Geophysical constraints on the reliability of solar and wind power worldwide

REVIEWER COMMENTS

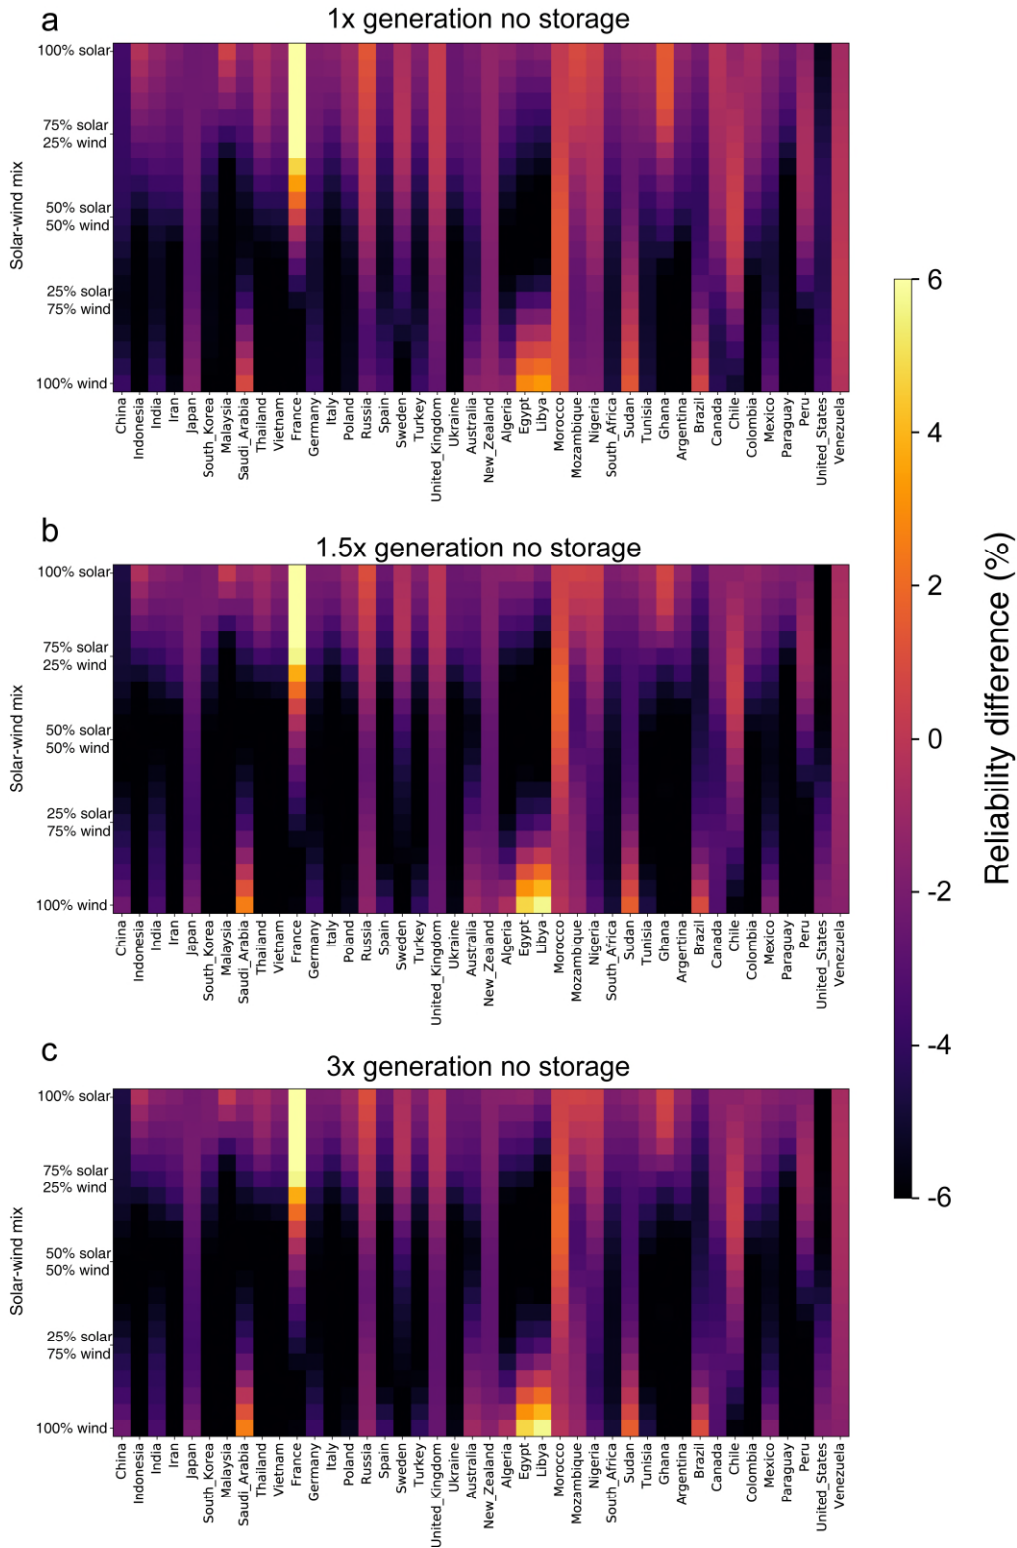
1. Most importantly, are you really exploring/revealing any truly any fundamental geophysical constraints here? Isn't it a matter of economics in the end that will constraint (or land area/siting challenges that may bind even before economics)? So long as there are no hours with both zero solar and zero wind output, it should be mathematically possible to create a convex combination of wind and solar capacities that meet demand in all hours. If you add storage to the mix, then this gets easier. Even in countries with one or more hours of zero combined wind and solar output (e.g. a becalmed night), storage capacity can shift output from other periods to this time and achieve supply/demand balance. So what is the geophysical constraint or limit? There isn't really one, is there? You are revealing geophysical *considerations* or *dynamics* inherent in the temporal variability of wind and solar at different locations and spatial scales and across interannual variability. This is insightful in and of itself, but the real limits or constraints on renewables-dominated systems come from the economic and/or socio-political limitations that arise, in part, from these geophysical dynamics. (I had the same thoughts upon reading Shaner et al., and this new work raises them all again).

Response: We thank the Reviewer for the thoughtful comments. Reading the comment carefully, any disagreement we have relates to the strength of the word "constraint." By constraint, we do not mean to suggest an absolute limit that determines whether it is possible to meet electricity demand, but rather a critical factor that in turn may make reliable systems economically or socio-politically infeasible. The Reviewer acknowledges that relationship (e.g., "...economic and/or socio-political limitations that arise, in part, from these geophysical dynamics"), but interprets "constraint" as hard limit instead of an important restriction. In response to the comment, and recognizing that other readers might interpret "constraint" in this stronger sense but lacking a better word, we have added a sentence early in the text (Lines 43-45) that explains what we intend by "constraint" (Lines 43-45).

More particularly, we agree the Reviewer it's mathematically possible to create a convex combination of wind and solar capacities that meet demand in all hours, but, for example, our results show that the total capacity needed to meet a given country's demand in all hours increases exponentially after a point that depends on the renewable resources of that country, and it is this geophysically-dependent point that will largely determine the cost-effectiveness

of highly-reliable, renewables-based electricity systems. As noted above, we have revised the main text to reflect these points more clearly and hope that it allays the Reviewer's concerns (Lines 196-201).

“Note that we do not mean to suggest that the temporal variability of such resources would ever make it physically impossible to meet a given electricity demand, but rather the extent to which such variability may determine the economic or socio-political feasibility of reliable systems.”

“Although with vast enough wind and solar capacity it might still be possible to meet demand in all hours, the required capacity increases exponentially after a point that depends on the renewable resources of that country, and it is this geophysically-dependent point that will largely determine the cost-effectiveness of highly-reliable, renewables-based electricity systems.”

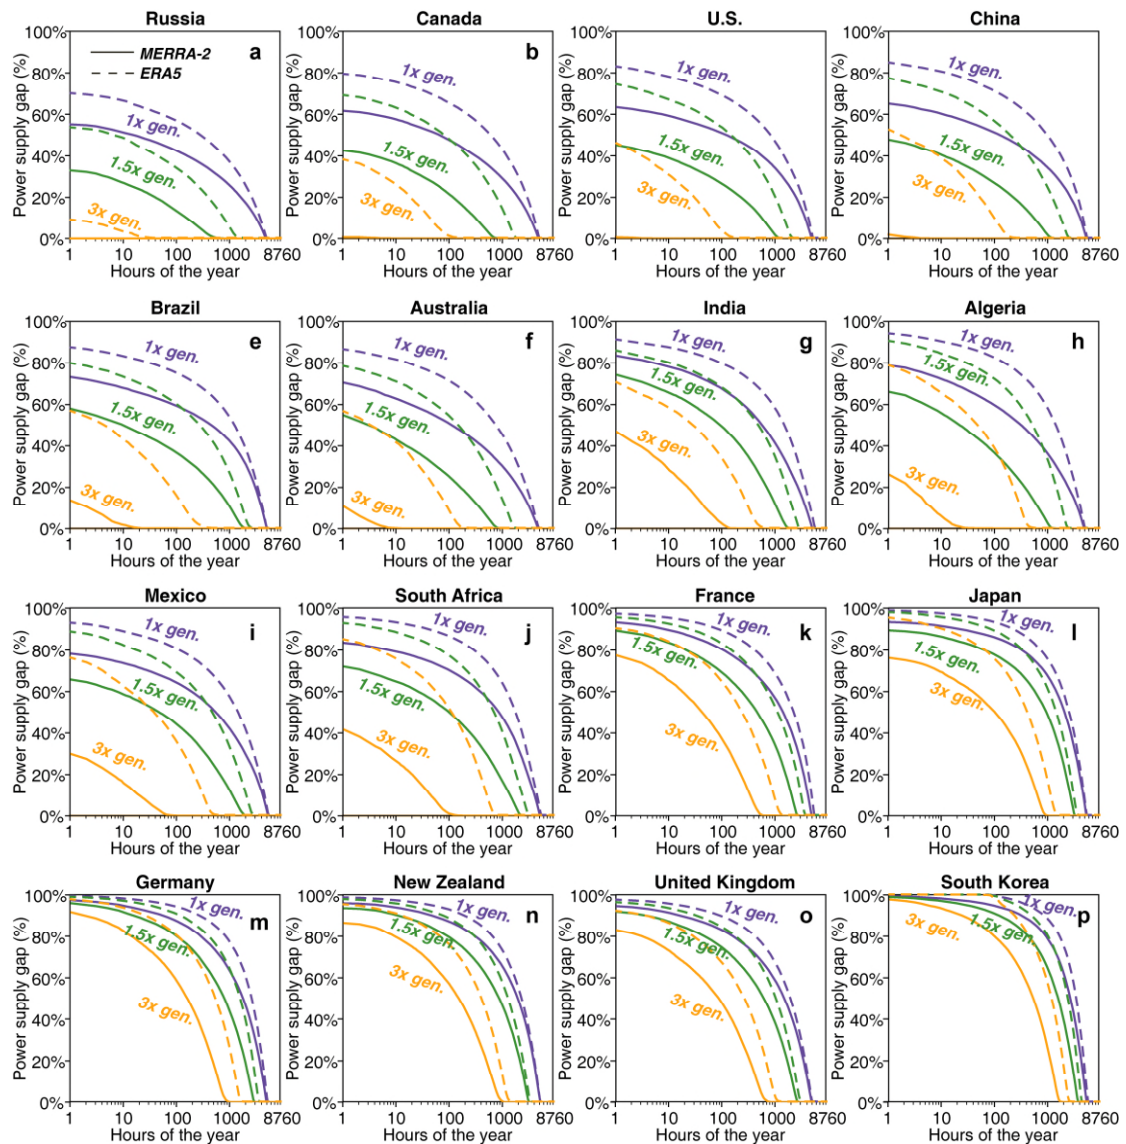
2. How do you validate your time series data (wind and solar simulations) and correct for biases in the hourly profiles of wind (and solar if relevant) in the reanalysis data? Reanalysis data series are known to have some challenges capturing in particular diurnal patterns of wind power output in some regions. The methods discussion mentions trying to correct annual capacity factors, which is a good step. But what about temporal patterns? As this is your focus here (hourly resolution variability in wind and solar series), this seems key, not just adjustments to correct bias in annual capacity factors.

Response: This is a good point, and we agree that hourly variations in the reanalysis data we used (MERRA-2) may be biased. In the revised manuscript, we have added new analyses based on a different and independent reanalysis product, ERA5, and compared the results. The somewhat different patterns of resource variability in the two datasets do not alter our main conclusions (see Supplementary Text 3 and Supplementary Figures S9-S10).

As shown in Supplementary Figure 9, our estimates of the system reliabilities by using ERA5 data in the 42 major countries are in good agreement with results of MERRA-2: under 1x generation and the most reliable mixes without storage, reliability under the different loads varies on average from -9.4% to 1.3% (see Fig. S9a). The differences are similar in systems with excess generation (Figs. S9).

Supplementary Figure 11 | The impacts of future high electrification demand profile on the system reliability in the U.S..

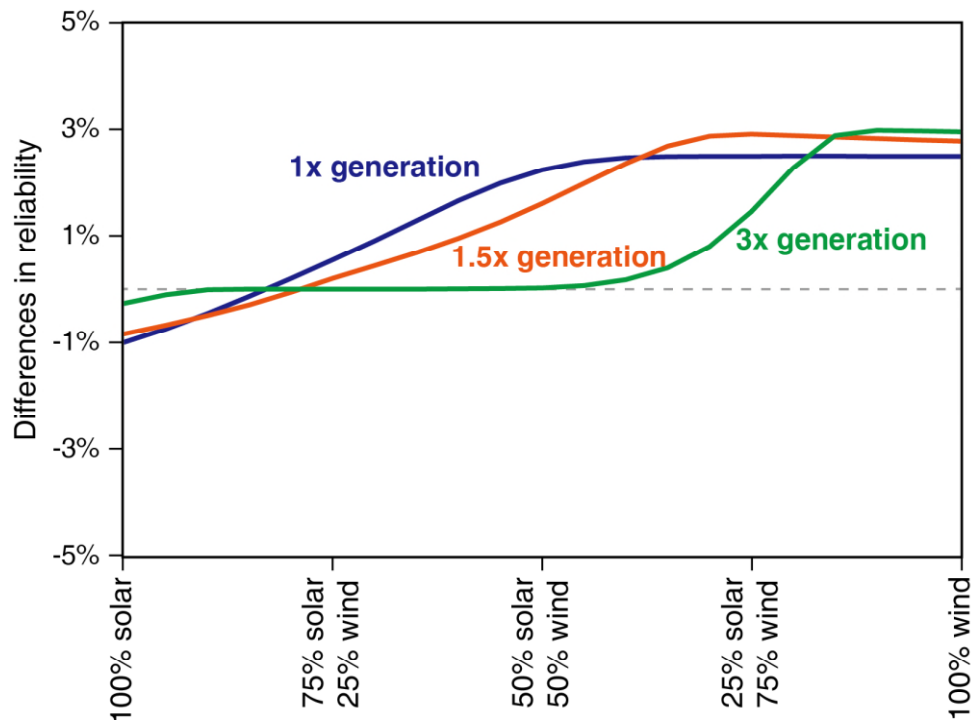
p. 2, "Electricity demand profiles for each country are determined by factors such as economic conditions, prevailing weather conditions and consumer usage patterns" - Note for the reader that you are using historic demand patterns and are not capturing plausible changes in demand due to electrification, managed charging/flexible loads, or introduction of electrolysis or other large flexible demands in future years concurrent with high penetrations of renewables. Another important limitation to note. Electrification can dramatically change demand profiles, particularly in northern latitude countries not currently dependent on electric heat. This changes both the diurnal and seasonal patterns of demand (e.g. shift to winter, overnight peaks) in ways that significantly affects the capacity value of resources (e.g. generally much lower for solar and better for wind, although it depends on the local wind patterns). (Note: France's greater seasonality discussed later in the same paragraph is due to prevalence of resistance electric heating btw. A presage of things to come with higher electrification of heating.)

p. 7-8, discussion of sensitivity to load profile or lack thereof - I would be surprised if it were this insensitive to high levels of transport and heating electrification, which significantly shift the seasonal pattern and peakiness of demand. You could try using a demand pattern from the NREL Electrification Futures Study high electrification scenario to test this.

Response: We agree that changes in the temporal patterns of demand could substantially affect our results.

As suggested in a subsequent comment by the Reviewer, we have performed new analyses using the demand pattern from the high electrification scenario in the NREL Electrification Futures Study and use the results to discuss the sensitivity of our results to such different load profiles.

For example, the results of this test for the U.S. show that reliability is not especially sensitive to the high electrification demand profile: under 1x generation without storage, reliability under the different renewable mixes varies on average from -1% to 2.5% (see Supplementary Fig. S11). The differences are even smaller in solar-heavy systems with excess generation.

Response: We really appreciate this constructive suggestion. As mentioned above, we have performed additional analyses using the demand pattern in the NREL study as suggested. When combining the high electrification scenario and rapid technology advancement for the U.S., our results show that reliability is not especially sensitive to demand profile: under 1x generation without storage, reliability under the different mixes varies on average from -1% to 2.5% (see Fig. S11 above).
